DEPARTMENT OF DEFENCE

TECHNICAL INVESTIGATION NO 778

EVALUATION OF NEW IROQUOIS TORQUEMETER PN 73-30-1

FIGURE 3.1 - DIFFERENTIAL OIL PRESSURE VS ACTUAL TORQUE

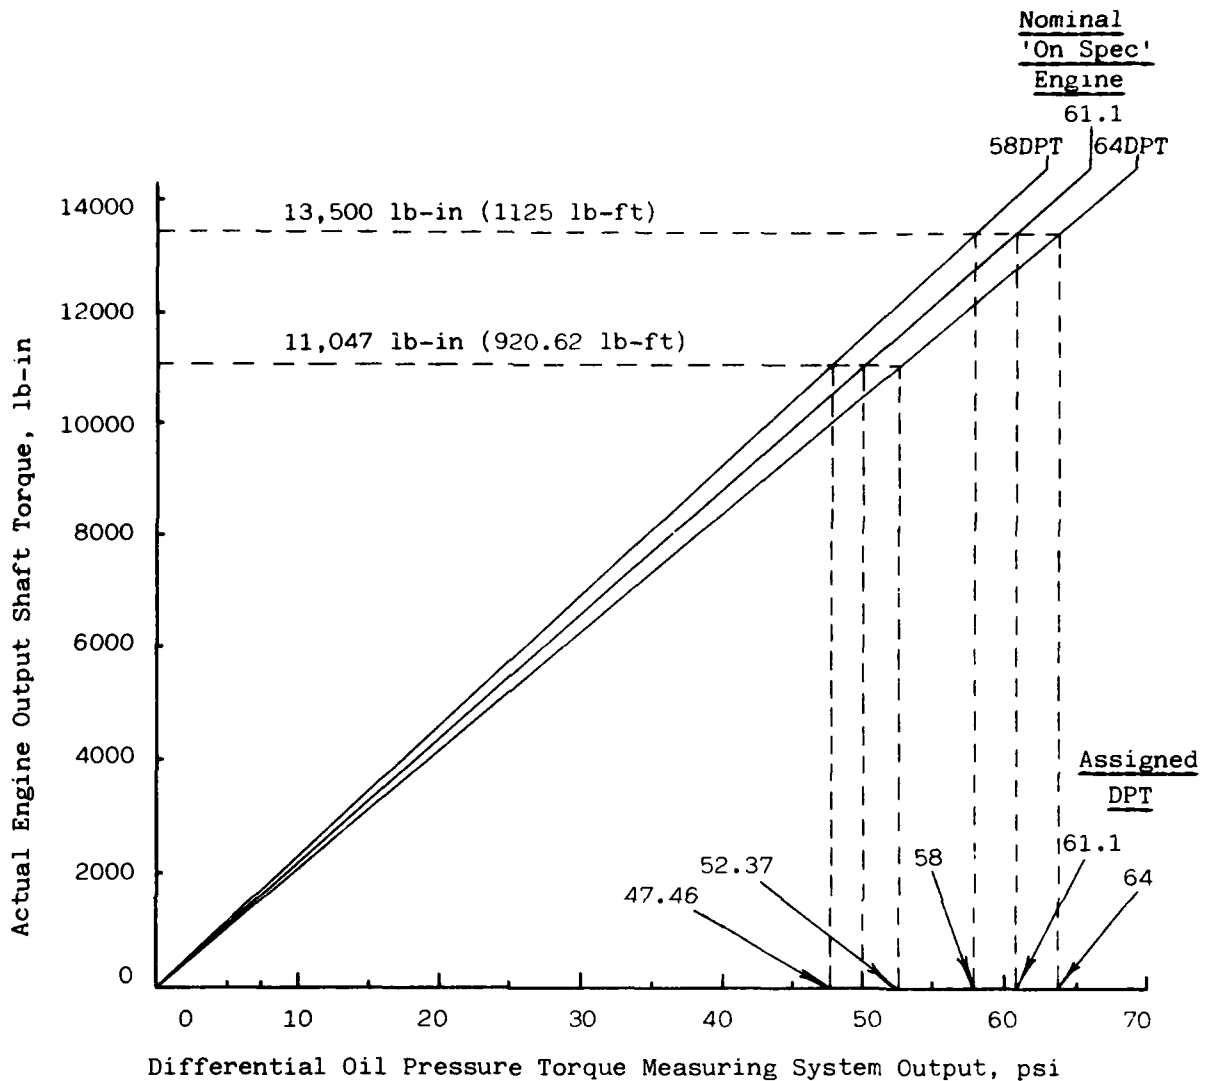
3.4.3 Proposed Adjustment Procedure. In the Lycoming T53-L-13B engine, output shaft torque is measured indirectly by sensing differential oil pressure. The variance of differential oil pressure between engines for the same actual torque output is reflected by the various DPT figures. The differential oil pressure is sensed by a transducer mounted on the engine and transmitted to the cockpit-mounted torquemeter. This indirect method of torque measurement causes significant errors. To minimize these errors, a revised torquemeter adjustment procedure is proposed by ARDU and is outlined at Annex B. The procedure is based on some assumptions and logic as follows:

- a. Differential Oil Pressure Versus Actual Torque. Differential oil pressure versus actual engine torque is assumed to be linear over the range and to converge on the origin for different DPT engines. This is illustrated in Figure 3.1.

FIGURE 3.2 - MODIFIED GRADATION MARKS AND POINTER

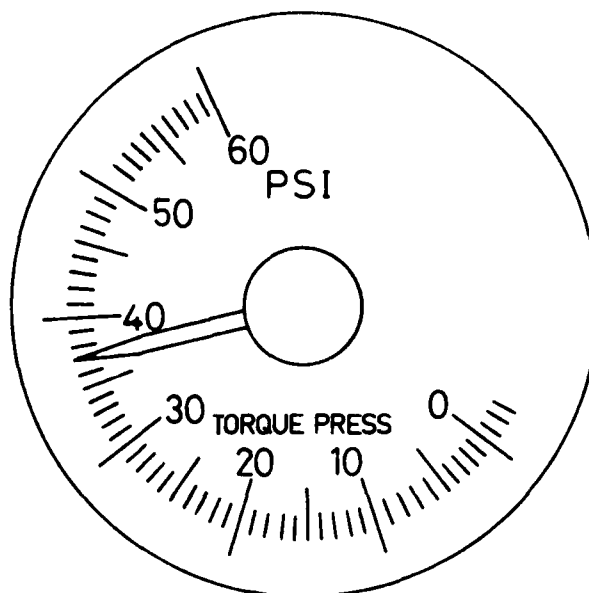
3.7.3 Pointer and Gradation Marks. The following modifications to the pointer and gradation marks are recommended to help alleviate deficiencies outlined in Paragraphs 3.7.1 and 3.7.2:

- a. Incremental 5 psi Marks. The gradation marks at increments of 5 psi should be extended inwards instead of outwards. This would help compensate for the obscuration of the markings when viewed from the co-pilot's seat.
- b. Pointer Taper and Length. The pointer should be more finely tapered (eg similar to the EGT indicator pointer) and extended slightly so that the tip reaches approximately the middle of the gradation marks. This would help to reduce parallax errors.

A sketch of the indicator face, incorporating the proposed modifications, is shown in Figure 3.2.

FIGURE 3.3 - LIGHTING LEVELS

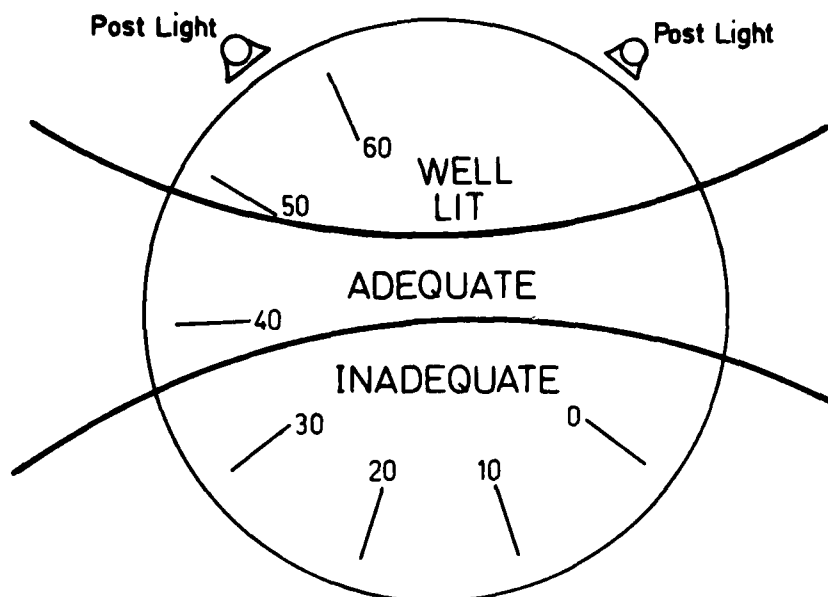
3.7.5 Lighting. The instrument was lit by two red filtered post lights mounted above the instrument at the approximate relative positions of eleven and one o'clock. Instrument lighting was assessed at night with the lighting intensity adjusted to approximately mid-range (representative of the selection made by most pilots for night operations). Figure 3.3 illustrates the light dispersion pattern which resulted. The post light at the one o'clock position virtually provided no illumination of the scale area and served no useful purpose. The red-painted gradation mark at 50 psi blended with the other gradation marks and was difficult to discern from other markings. Inadequate lighting of the scale from zero psi to approximately 35 psi will cause difficulty in reading engine torque during cruise flight and descent when conducting night operations. The night-lighting of the instrument was unsatisfactory and should be corrected to improve lighting in the zero to 35 psi area. Failure to correct this deficiency may force use of higher than necessary overall lighting levels to accommodate the inability to see this area of the instrument.

5.4 The night-lighting of the instrument should be improved so that the whole of the scale is adequately lit (Paragraph 3.7.5).

FIGURE 1 - TORQUEMETER ADJUSTMENT GRAPH

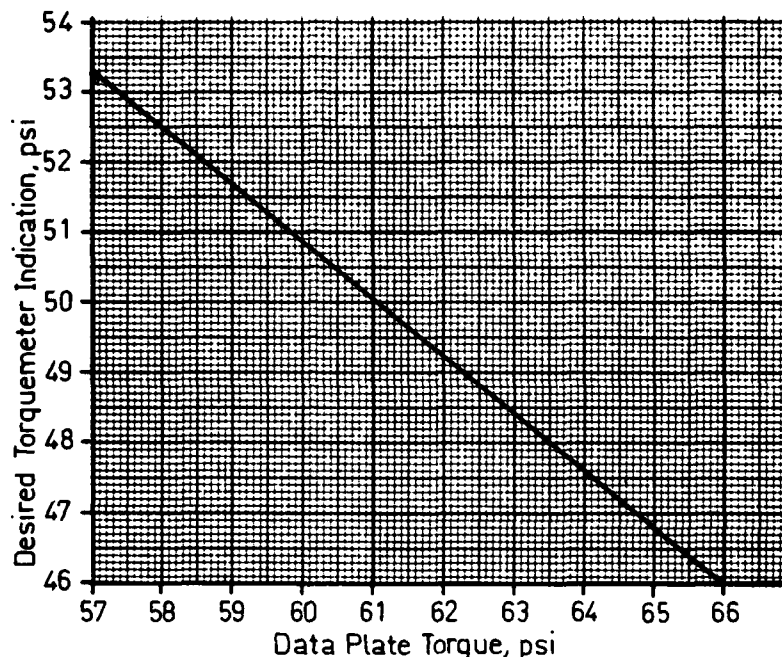
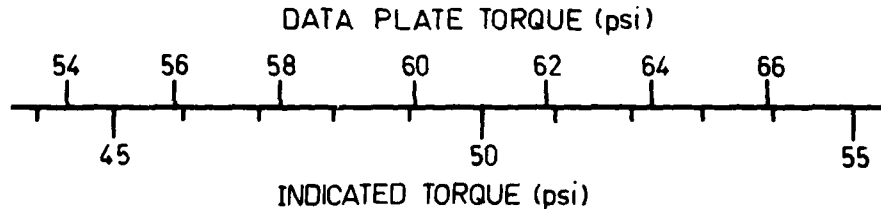
3.4.1 Introduction. Reference C, Paragraph 1.e. contains a chart (reproduced as Table 3.5) for adjusting the torquemeter zero set for installed engine DPT. A DPT of 60.5 psi is cited as the nominal 'on specification' value. For DPT other than 60.5 psi, the torquemeter zero set was to be adjusted on a one-for-one basis with the aim of providing an accurate indication at 50 psi. Research at ARDU has revealed that there are faults with this adjustment methodology.

- a. Determine the Data Plate Torque (DPT) value of the installed engine.
- b. Enter the torquemeter adjustment graph, Figure 1, with DPT and determine the corresponding Desired Torquemeter Indication.

- c. Using the NP-1 portable hydraulic rig, pump the engine torque measuring system to 50 psi indicated on the calibrated NP-1 meter.
 - d. Use the 'zero set' adjustment on torquemeter PN 73-30-1 to make the instrument read the desired torquemeter indication determined in step b.

- e. Reduce the engine torque measuring system pressure to zero and place a reference decal on the face of torquemeter PN 73-30-1 at the indicated reading. This will be used as a guide to system serviceability (calibration) when an NP-1 rig is not available (eg during Before- and After-flight Inspections).

2. If an engine change is undertaken in the field and an NP-1 portable hydraulic rig is not available, the adjustment should be made at an engine torque measuring system pressure of zero. The indicator should be made to read the desired indication determined from Figure 1, MINUS 50 psi. The system should be properly calibrated as soon as an NP-1 hydraulic rig is available.
